IREDELL COUNTY HEALTH DEPARTMENT

IMPROVEMENT PERMIT / AUTHORIZATION TO CONSTRUCT / OPERATION PERMIT / EXISTING SYSTEM INSPECTION

PERMIT# 111584 PIN# ~~4723-70-1483.15~~ 4722-79-6918 DATE Nov. 13, 03

SUBDIVISION Davidson Woods BLOCK / SECTION _____ LOT 15/15A LOT AREA .46AC +.24AC SFE SITE CLASS. PS SFE 15A DESIGN FLOW 360gpd L.T.A.R. .25 SFE 15A

INITIAL SITE SKETCH

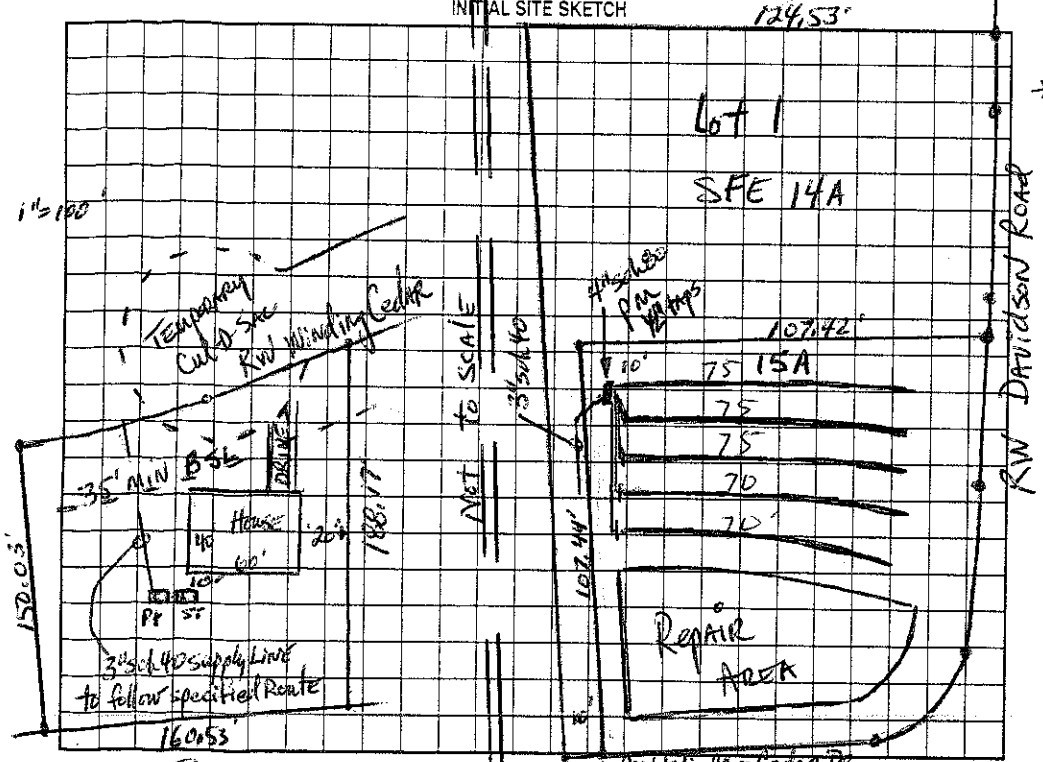
Comments:/Conditions: 10' minimum must be maintained between WW supply lines and parallel potable water line. Any crossing of these lines must be done in accordance w/ .1950 "F"

AS BUILT SKETCH

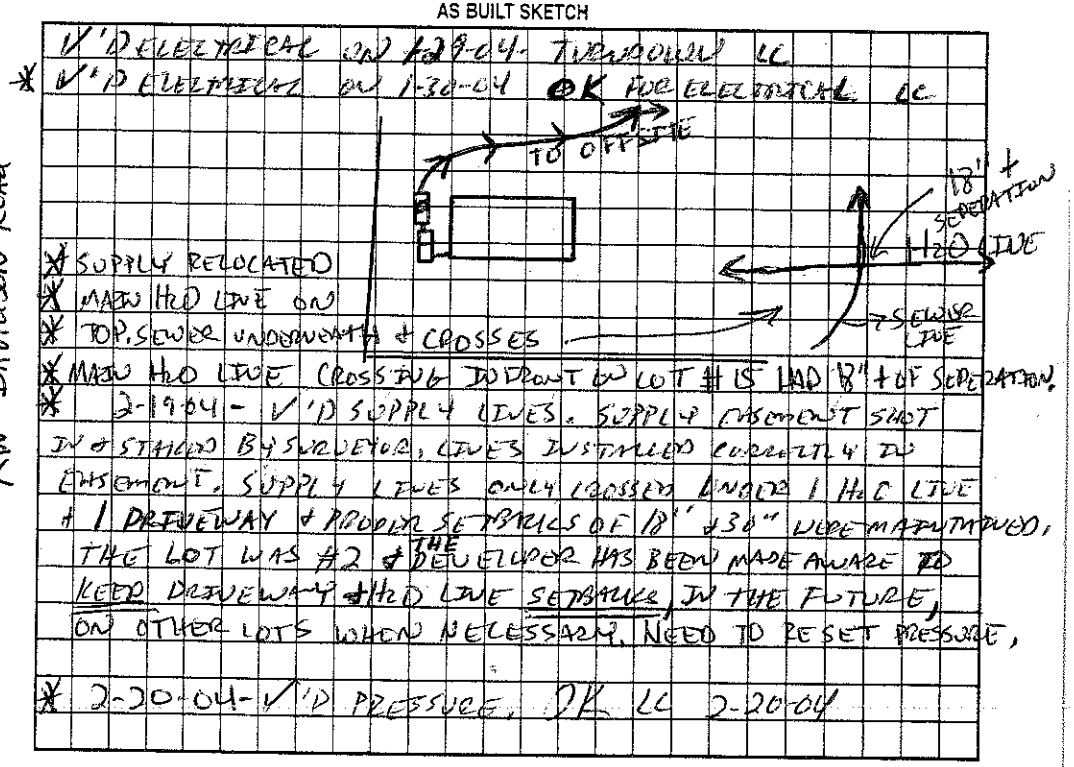
Comments:/Conditions: POLYLOK FILTER & MARKER

* V'D LINES & SET PRESSURE. PRESSURE NOT APPROVED. NO EASEMENT FROM THE STATE & DISTANCE FROM SUPPLY LINE & H2O LINE NOT KNOWN. LC 1-23-04 LC
